RE: Project Name: PRC2023- 00010 DevCo Arvada 64 Rezone and Minor Subdivision

Thank you for the comments on *May 3, 2023* for the above-mentioned project. In an effort to address your comments concisely and simplify your review of the Rezone and Minor Subdivision, we have summarized your comments and our responses below.

DEVELOPMENT TEAM REVIEW COMMENTS

BEING SITUATED IN THE NORTHEAST QUARTER OF SECTION 7, TOWNSHIP 3 SOUTH,
RANGE 68 WEST OF THE 6TH P.M., COUNTY OF ADAMS, STATE OF COLORADO
SHEET 1 OF 3

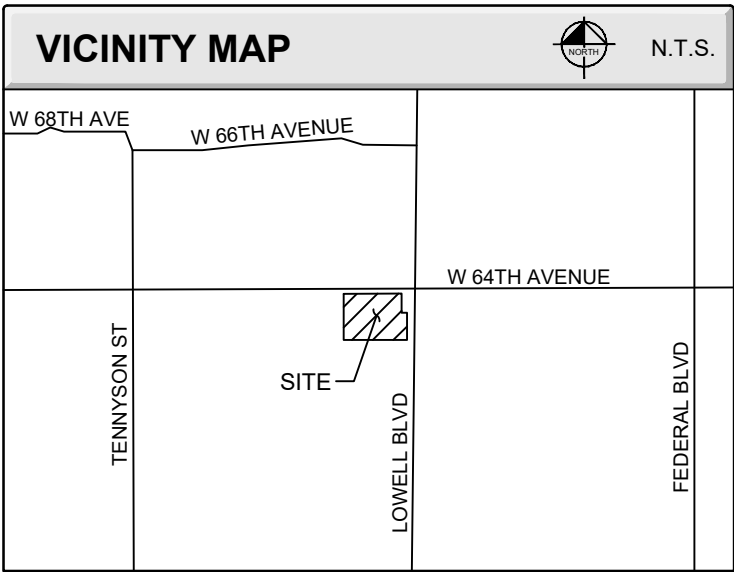
- ROW2: Provide a purpose statement as to what the plat is accomplishing.
- *Response: The purpose statement has been added to the plat. It reads, "PURPOSE STATEMENT: COMBINE TWO PARCELS INTO A SUBDIVISION TO COMPLY WITH STATE AND COUNTY REGULATIONS." Please see page 1 of the revised plat.*

- ROW5: Revise the salutation as: OWNERSHIP AND DEDICATION CERTIFICATE.
- *Response: The subdivision plat has been revised to address this comment. Please see page 1 of the revised plat.*

- ROW6: Add "BEING" SITUATED IN...
- *Response: The subdivision plat has been revised to address this comment. Please see page 1 of the revised plat.*

- ROW9: Need to plat those easements as stated in Note 3, and delete portion of Note 4 as provided on plat redlines
- *Response: The subdivision plat has been revised to address this comment. Please see page 1 of the revised plat.*

- ROW10: Revise dedication statement to read: LOT, BLOCK, TRACTS AND EASEMENTS

- ROW11: Revise Notary Affirmation as provided.
- *Response: The subdivision plat has been revised to address this comment. Please see page 1 of the revised plat.*

- ROW12: Need to add the signature/approval blocks for:
 PLANNING COMMISSION
 BOARD OF COUNTY COMMISSIONERS
 COUNTY ATTORNEY'S OFFICE
 - *Response: The subdivision plat has been revised to address this comment. Please see page 1 of the revised plat.*

- ROW13: Revise closure statement per state regulations.
 - *Response: The subdivision plat has been revised to address this comment. Please see page 1 of the revised plat.*

BEING SITUATED IN THE NORTHEAST QUARTER OF SECTION 7, TOWNSHIP 3 SOUTH,
RANGE 68 WEST OF THE 6TH P.M., COUNTY OF ADAMS, STATE OF COLORADO
SHEET 2 OF 3

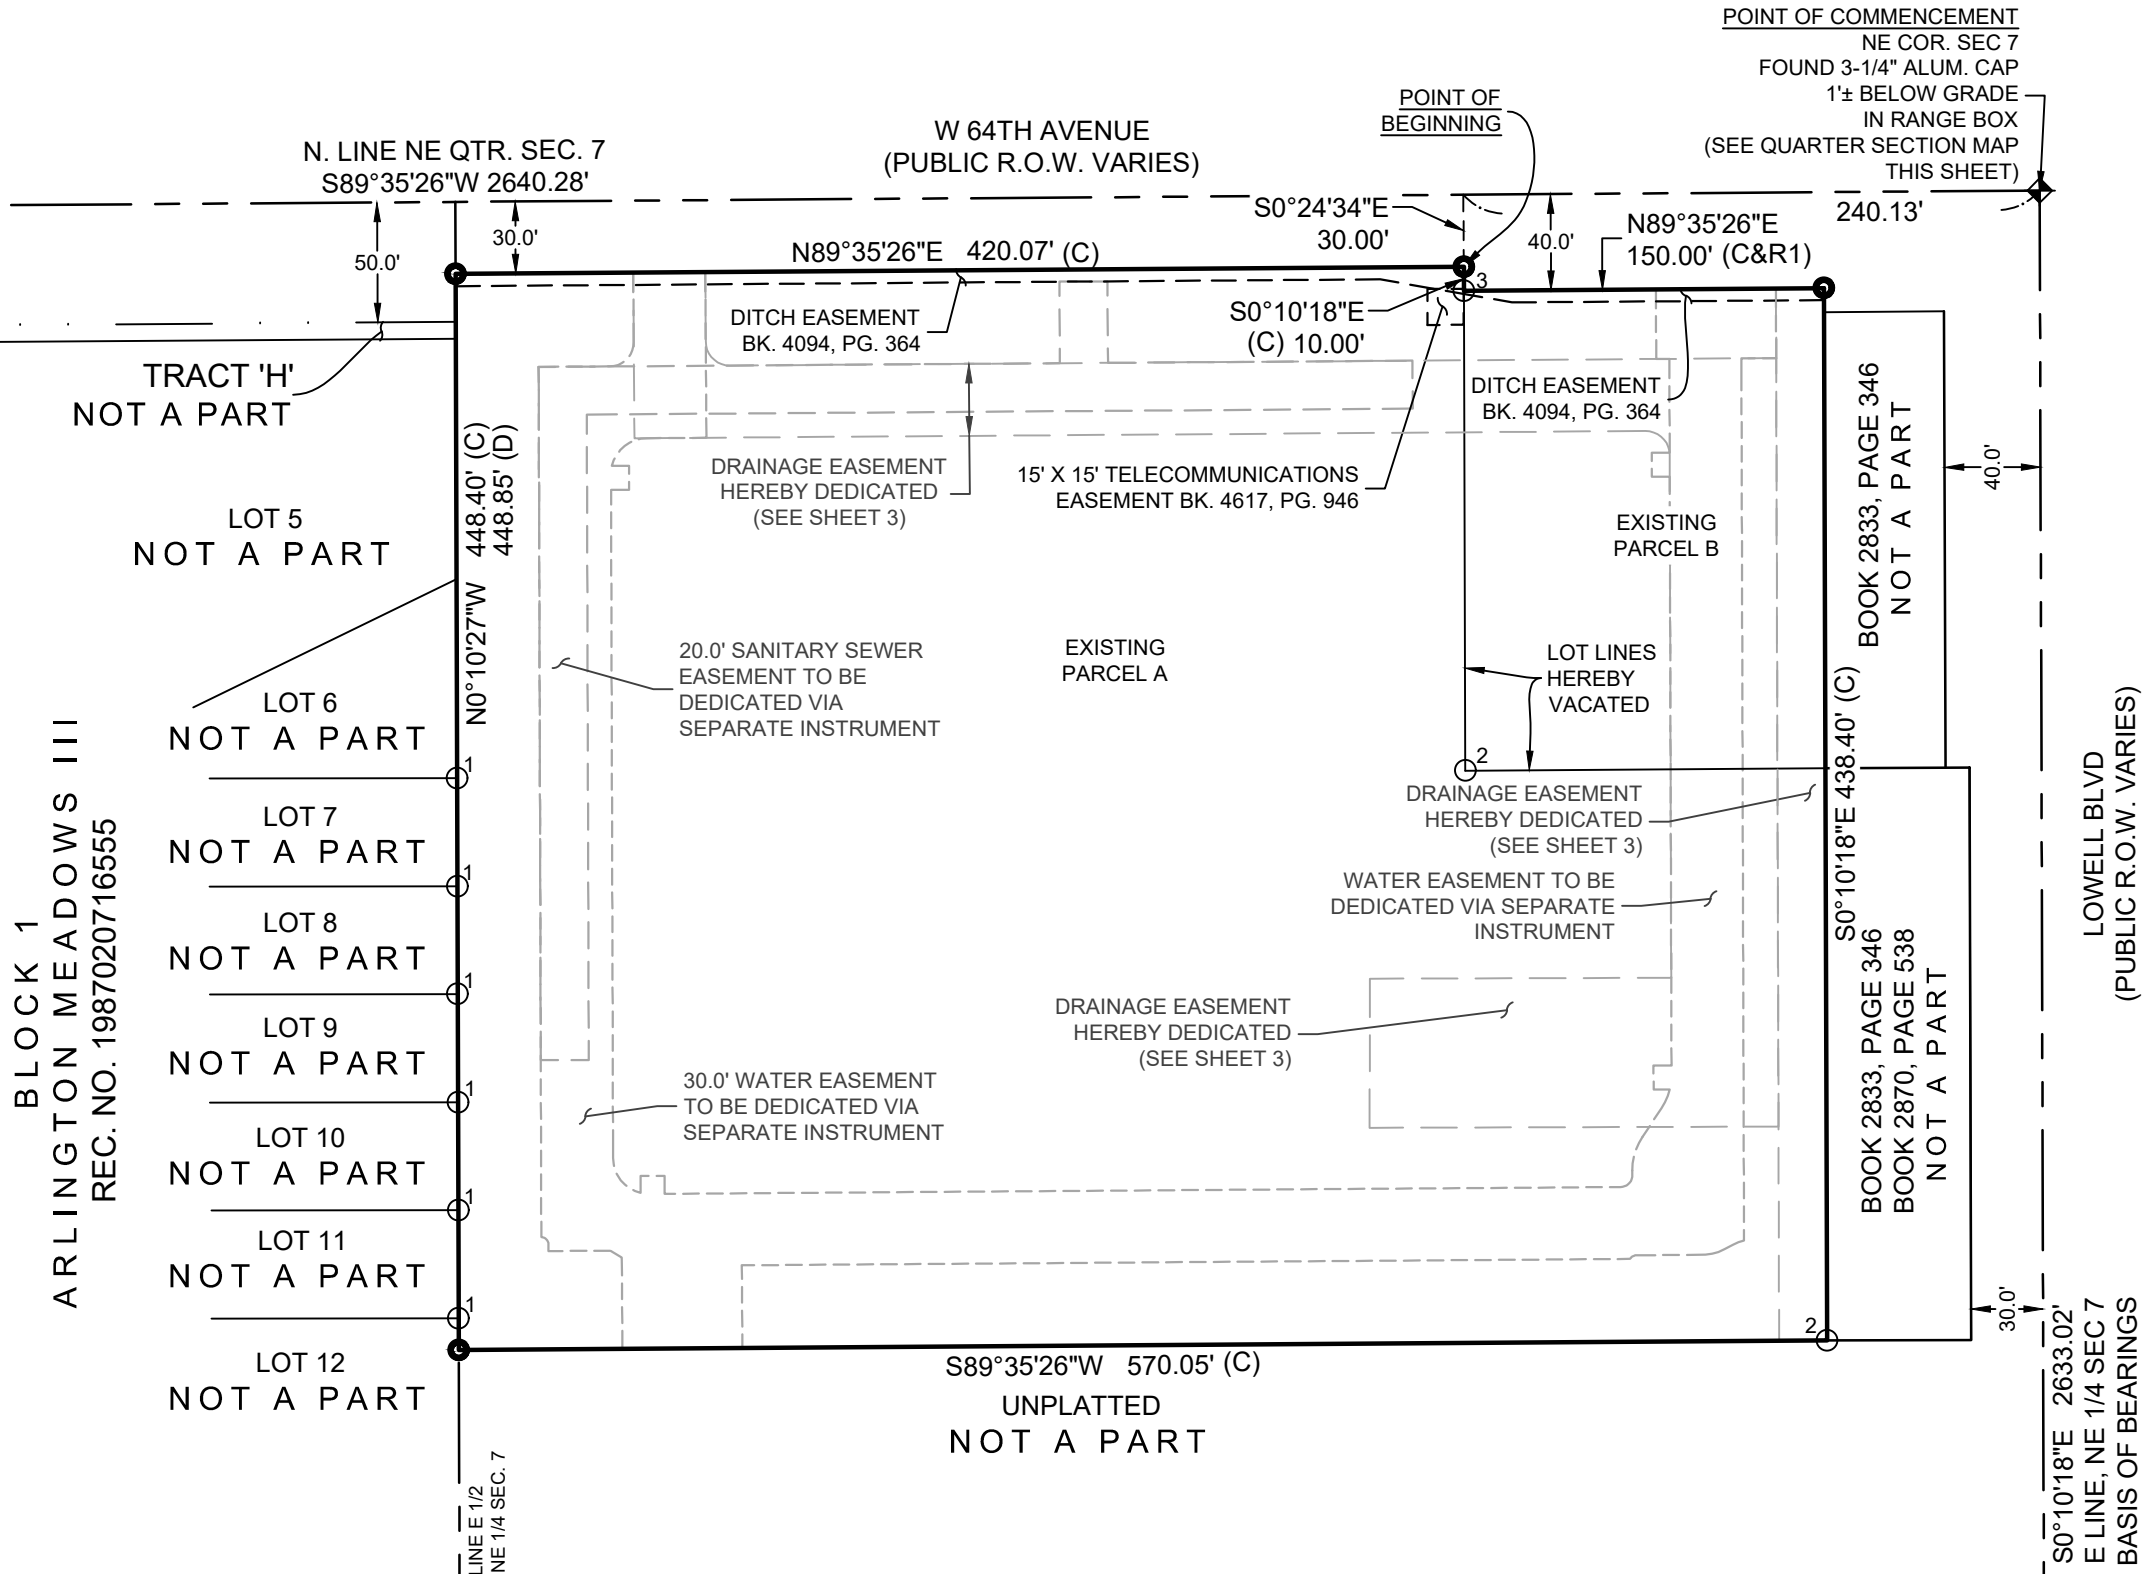
- ROW18: Must show the current lot lines and state "LOT LINE VACATED BY THIS PLAT"
*Pending review of subsequent revisions, additional comments may be provided beyond those provided herein.
- *Response: The subdivision plat has been revised to address this comment. Please see page 2 of the revised plat.*

BEING SITUATED IN THE NORTHEAST QUARTER OF SECTION 7, TOWNSHIP 3 SOUTH,
RANGE 68 WEST OF THE 6TH P.M., COUNTY OF ADAMS, STATE OF COLORADO
SHEET 3 OF 3

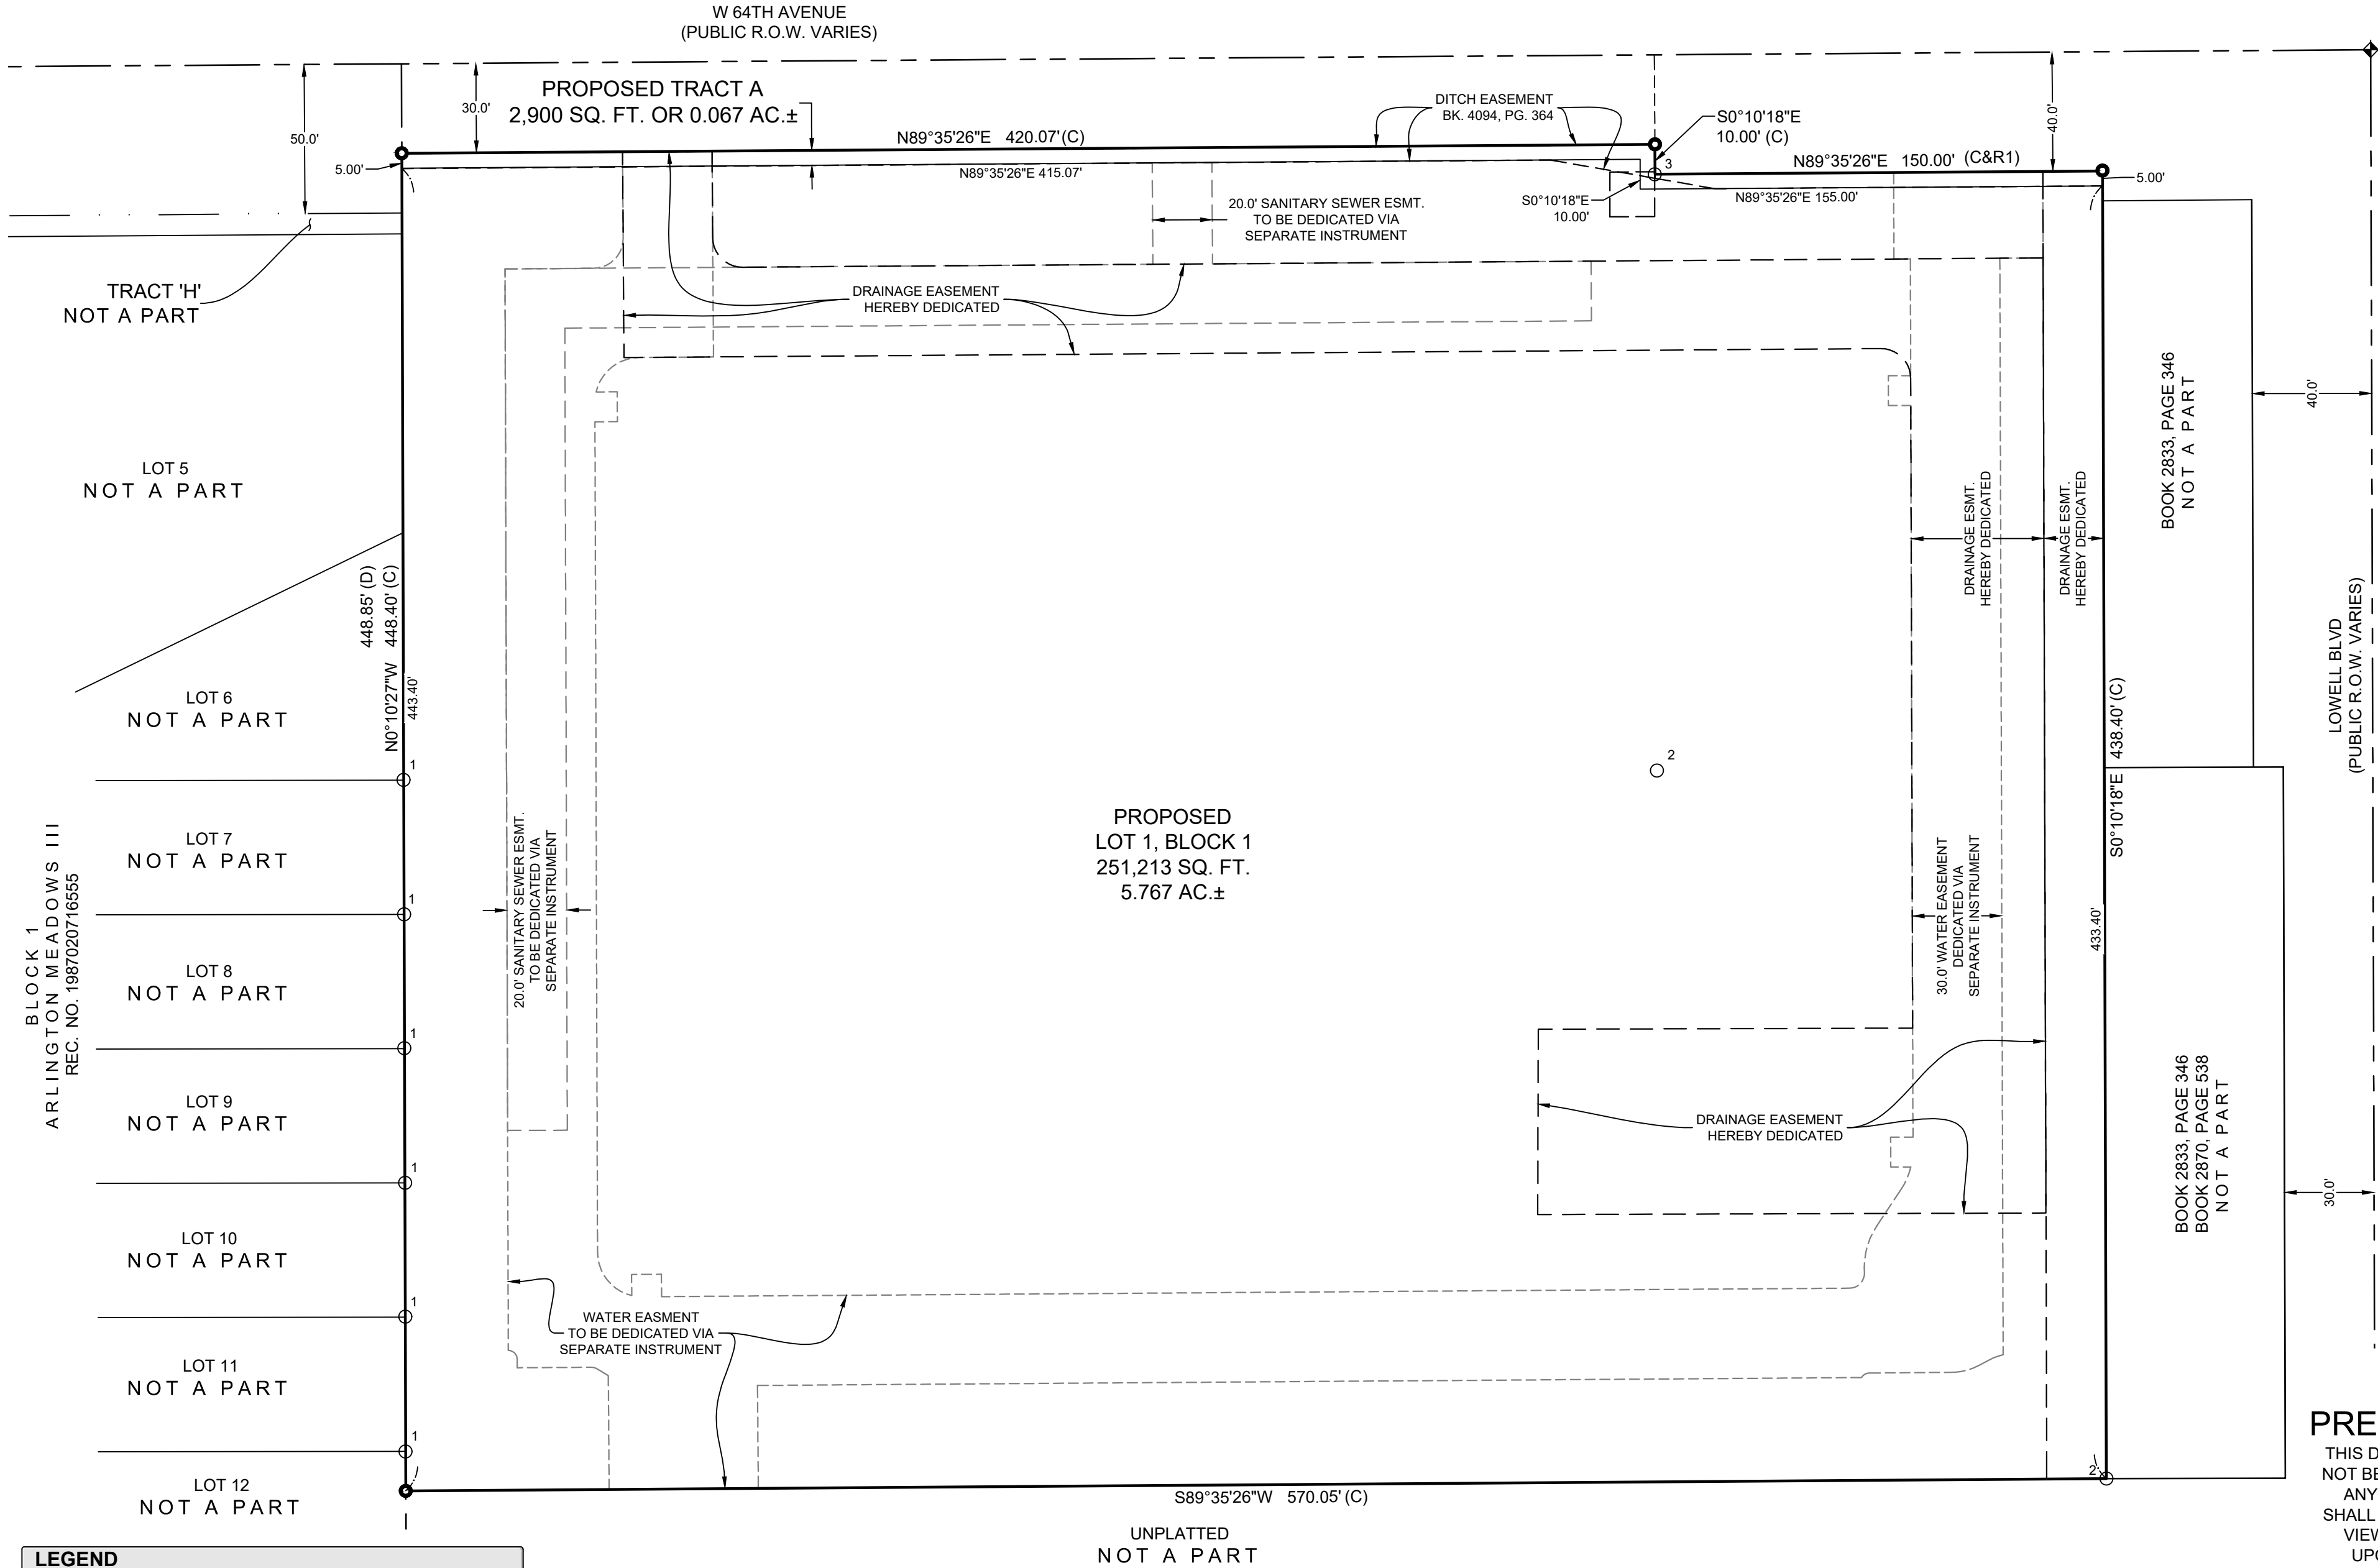
1. A landscape tract should be proposed along W. 64th Avenue. Per Section 3-16-06-06-05, The minimum setback for all accessory structures in a Residential-4 District from an arterial right-of-way shall be fifty (50) feet except a section line arterial right-of-way where the minimum setback shall be eighty (80) feet. The setback from collector and local rights-of-way shall be fifty (50) feet. The landscape tract will allow you to not meet the this setback.

- ROW15: TRACTS must be used for:
 Open space/common space
 Access/private drive
 Storm drainage facilities and access to same.
 - *Response: A landscape tract has been provided along the north edge of the site, adjacent to W 64th Avenue. Please see page 3 of the revised plat.*

- ROW16: Must have utility and drainage easements dedicated and provided in order to get utilities to the individual proposed buildings and shown on the plat.
 - *Response: Proposed utility easements are shown on the plat. Please see page 3 of the revised plat.*

- ROW17: Depending on Crestview's needs for water and sewer easements, these should be shown on the plat, and stated to be dedicated by separate instrument, or Crestview must be a party to the plat to accept the dedication of their easements.
 - *Response: Easements required by Crestview Water and Sanitation district and Denver Water will be shown on the plat, however they will be officially dedicated by separate instrument. Please see page 3 of the revised plat.*

- *Response: A landscape tract has been included on the subdivision plat. It is 5' wide and runs the length of the site's frontage along W 64th Ave. Please see page 3 of the revised plat.*
